REMARKS TO THE REPLACEMENT DRAWINGS

Amendments to Drawings

EXHIBIT A

Shown herein are all of the figures appearing in the immediate prior version of all (1-60) of the amended replacement drawing sheets.

Fig. 16A

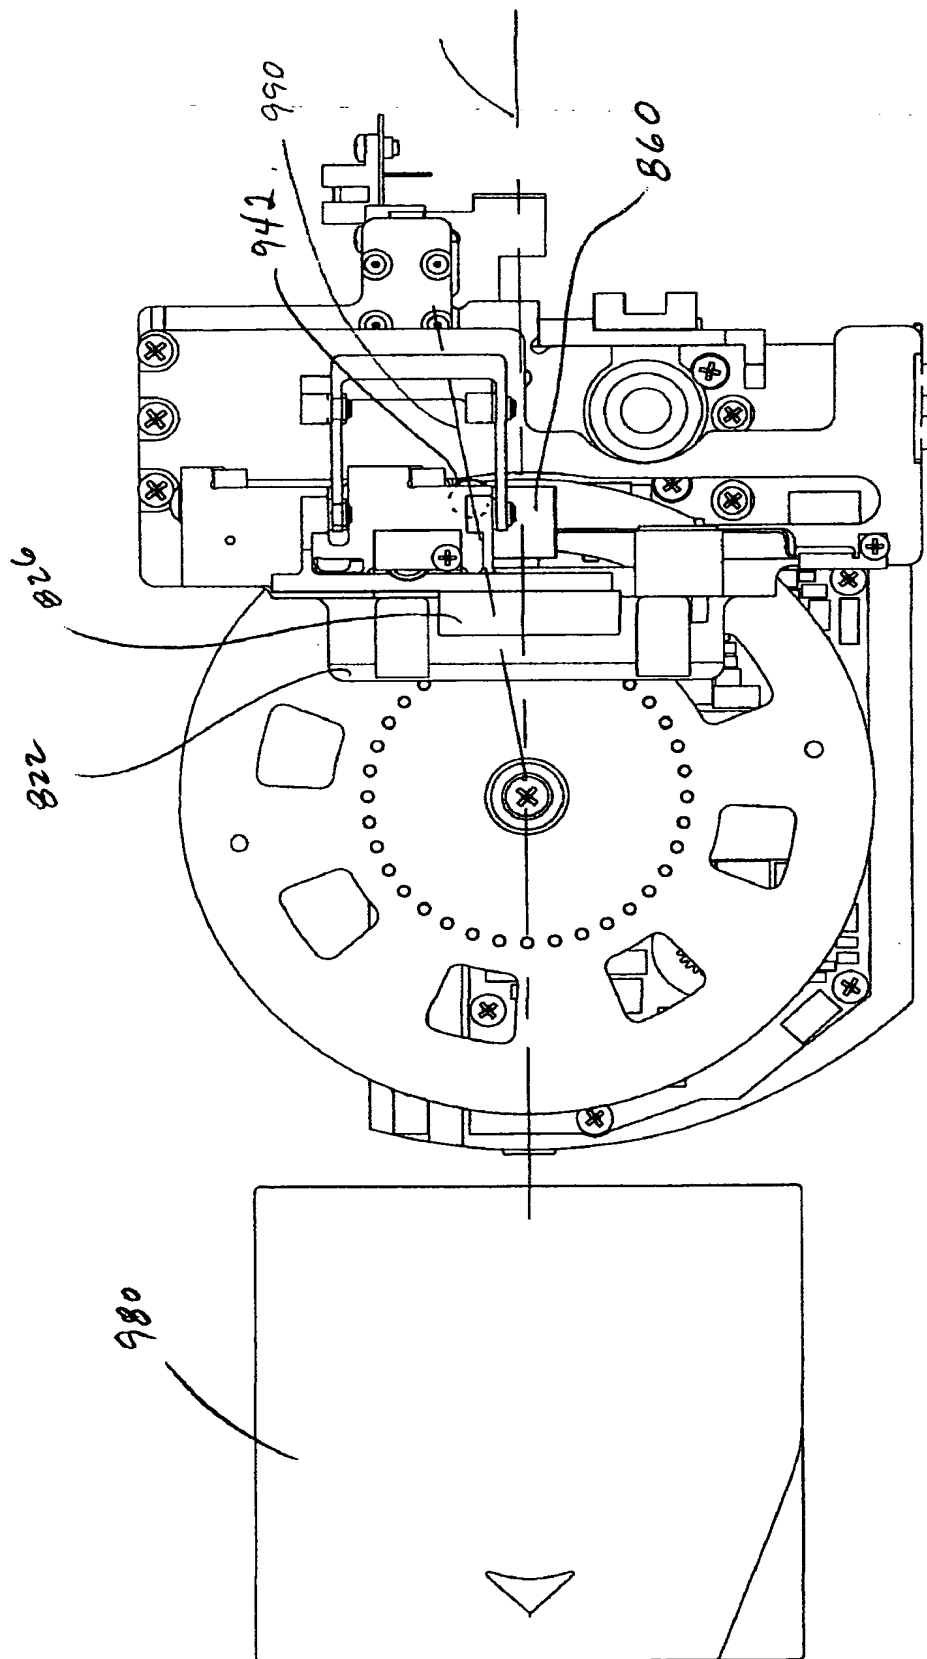
FIG. 16A is amended herein to add label 994 for the centerline of rotation of the crank 912 and replace 980 with 130 for the LTO tape cassette.

Fig. 16B

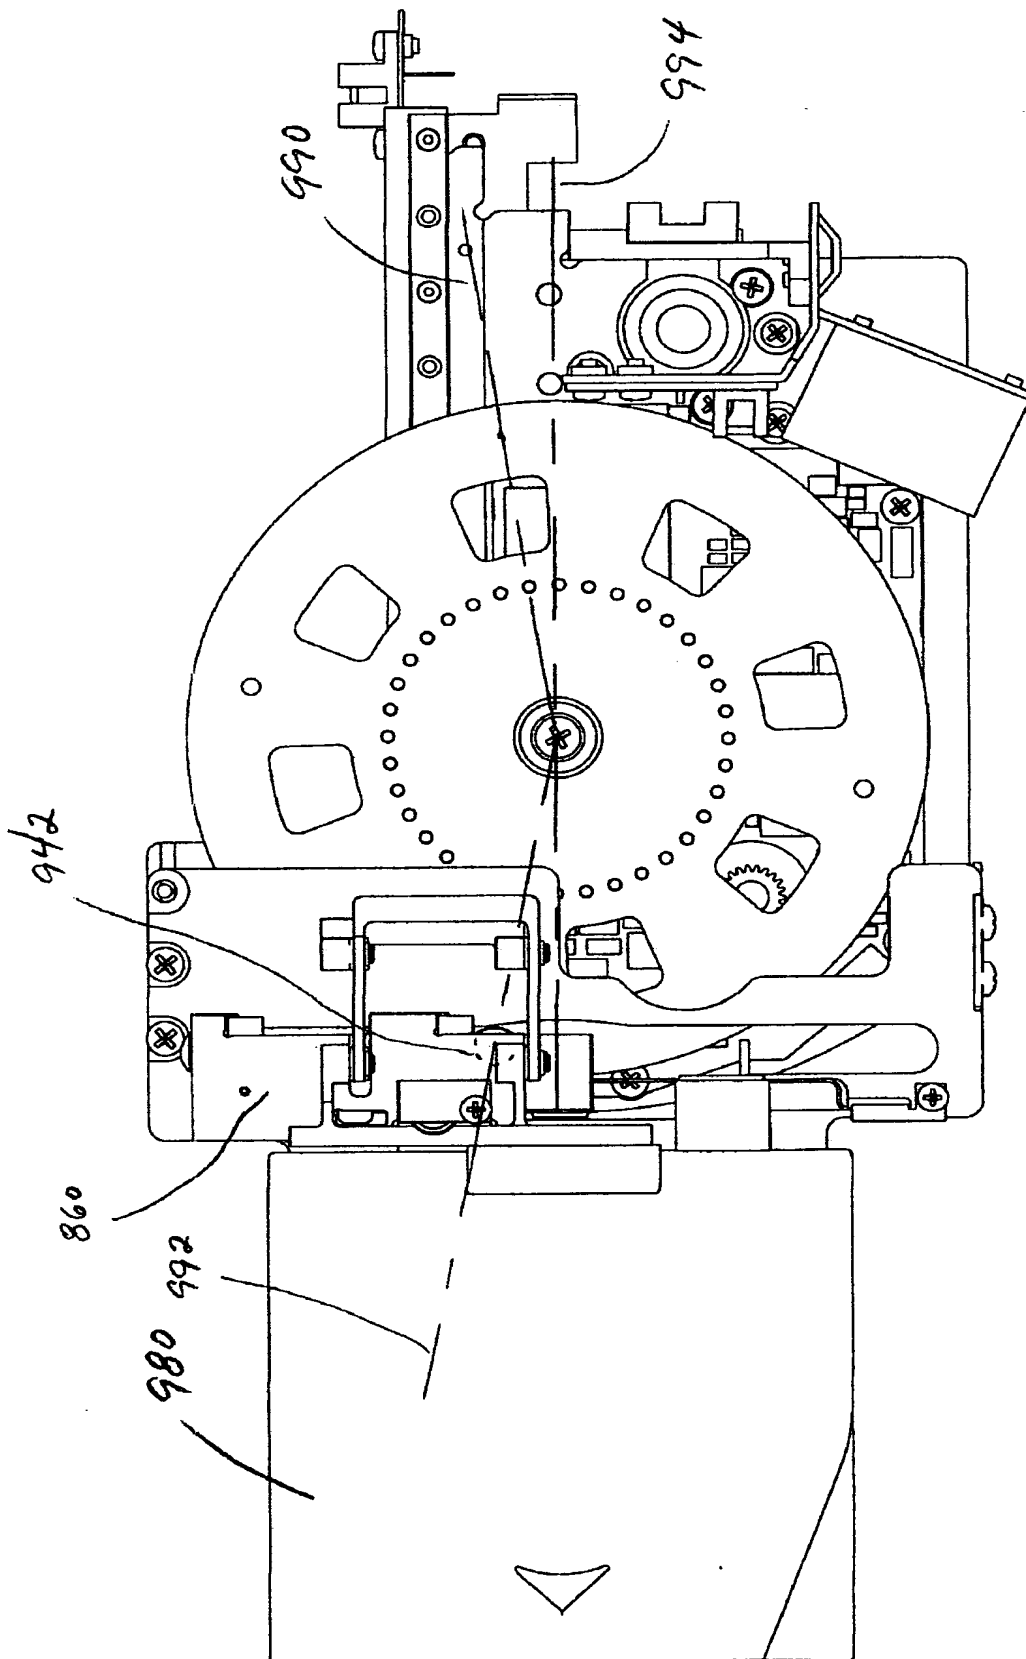
FIG. 16B is amended herein to replace 980 with 130 for the LTO tape cassette.

Fig. 16c

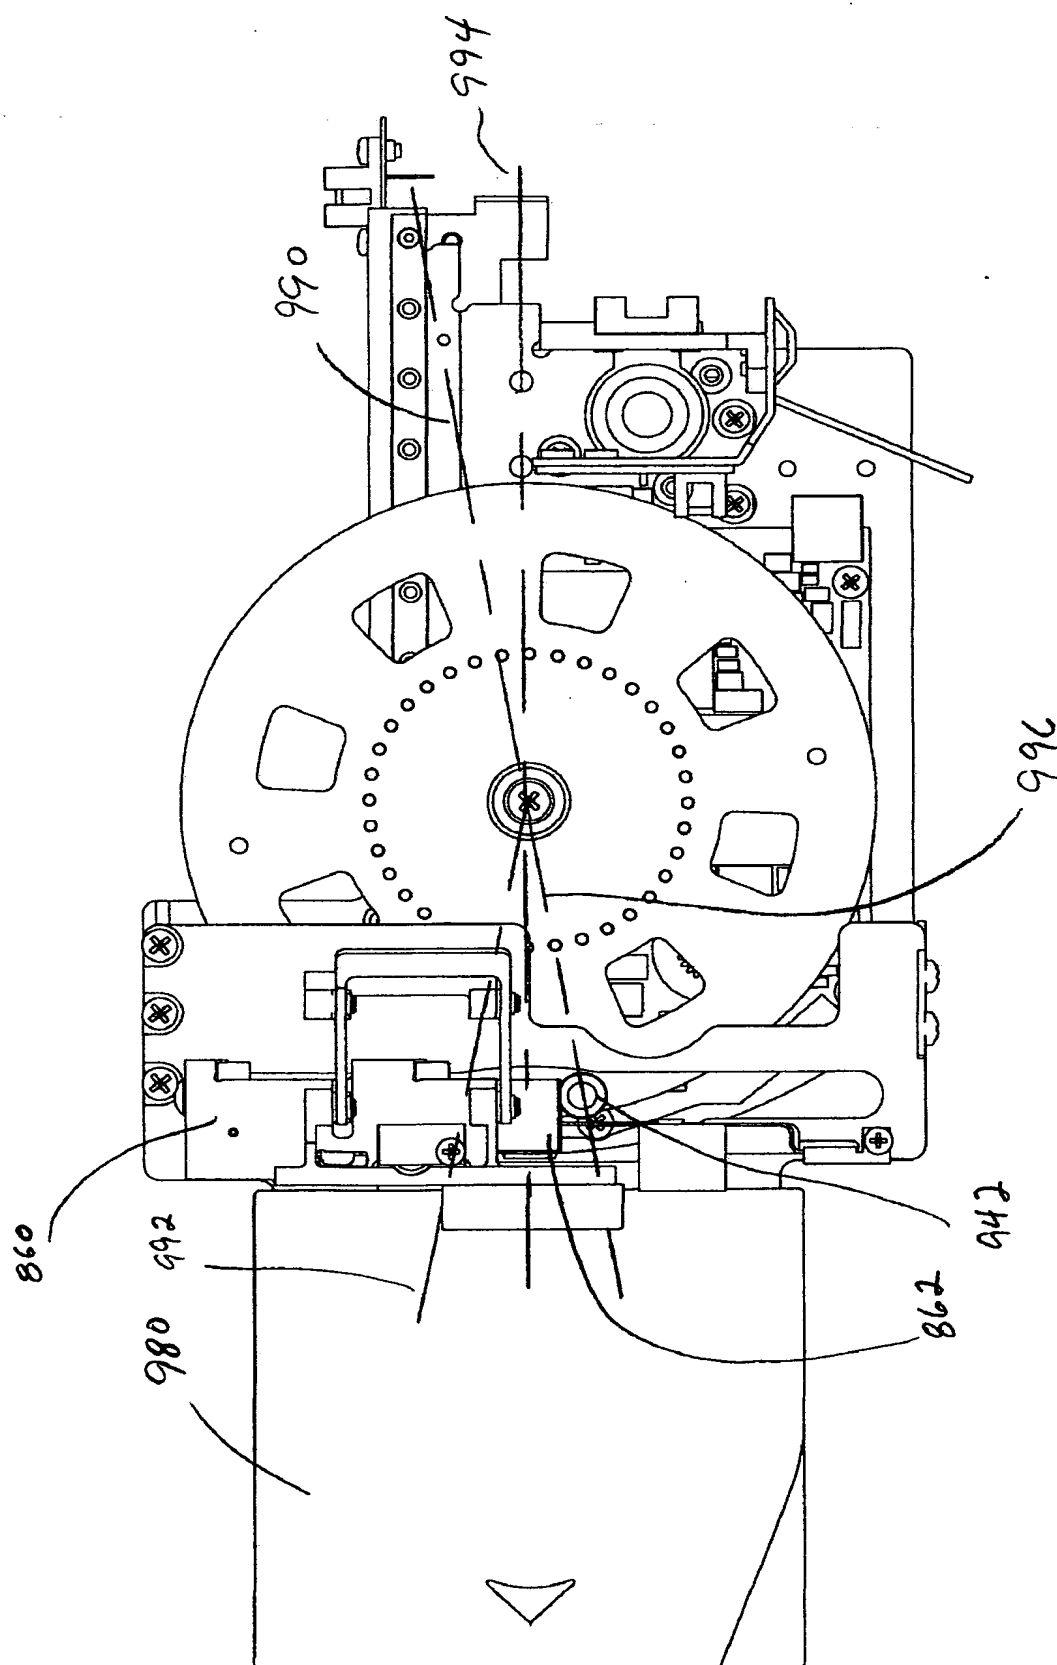
FIG. 16C is amended herein to replace 980 with 130 for the LTO tape cassette.
